SERVICE BULLETIN RMC-011

Product: Receiver Multicoupler

Subject: Firmware 1.63 Release

Date: 15th June 2018

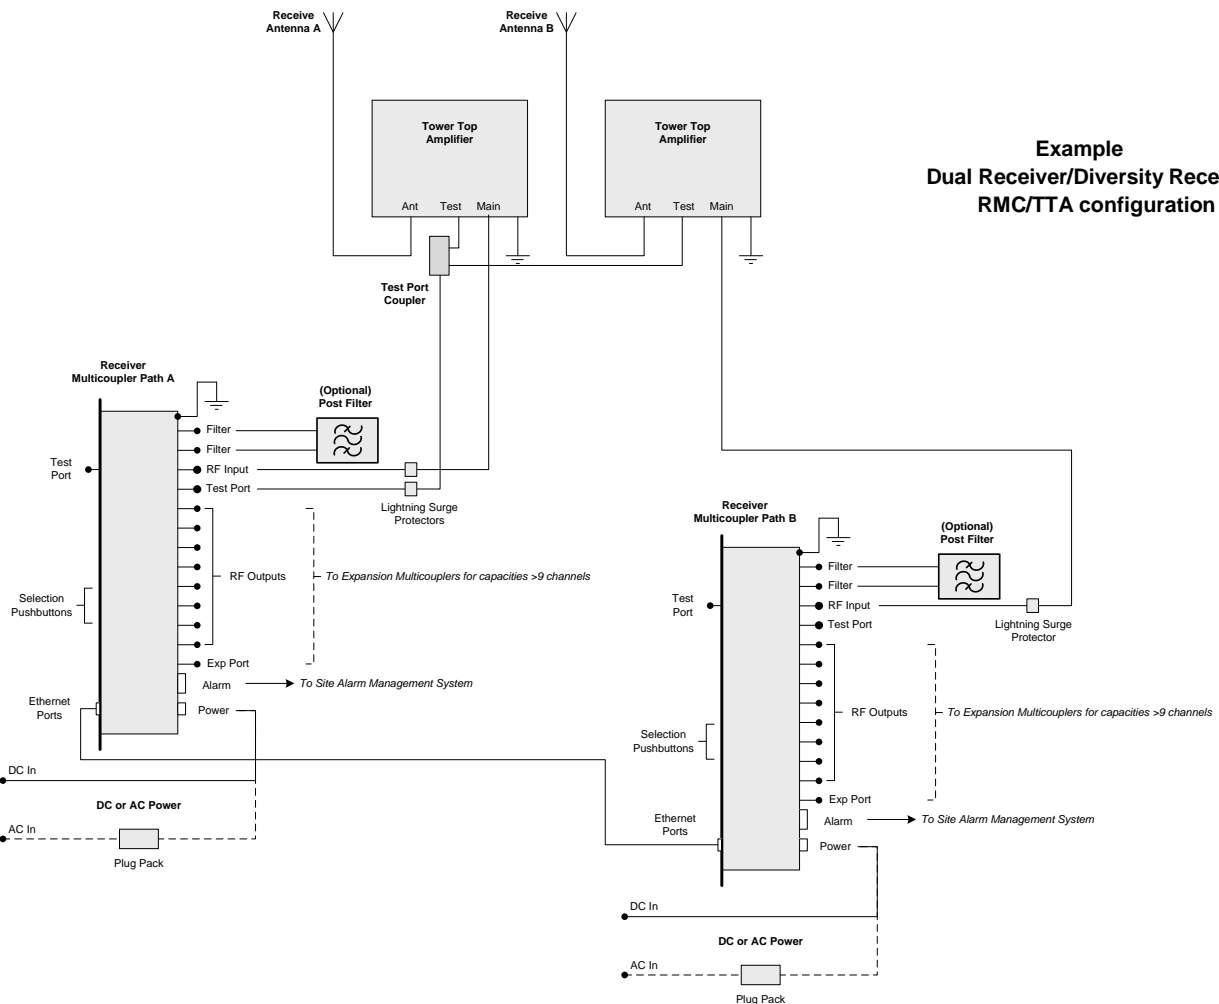
The RMC/TTA products are now available in configurations to support dual receiver/diversity receiver site equipment configurations.

In these applications a fully-redundant set of RMC and TTA equipment provides the two separate outputs for each channel's receivers.

The TTA Test port functionality is provided using a shared TEST coaxial feeder cable that is distributed between the two TTAs using a 2way coupler (the 'Test Port Coupler').

This version 1.63 firmware provides a Dual Receiver/Diversity Receiver selection in the GUI, changing the 30dB TTA Test port value to 33dB, compensating calculations for the inclusion of the Test Port Coupler in system.
